Product Change Notification

PCN-IFC-449-2017

The B series push-in (PT) inserts will be upgraded via a change in the insulating material – from Polyamide(PA) to Polycarbonate (PC).

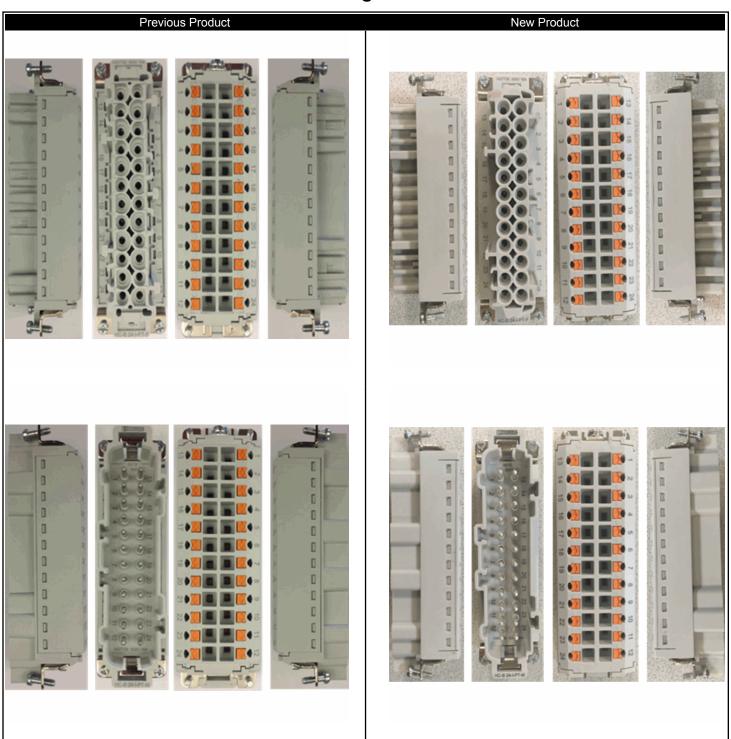
Small, visible modifications to the geometry of the insert have been made only to optimize the flow of plastic in the molding process, and to improve our integrated quality control.

The new inserts are fully intermateable and interchangeable with the old inserts and with competitor inserts.
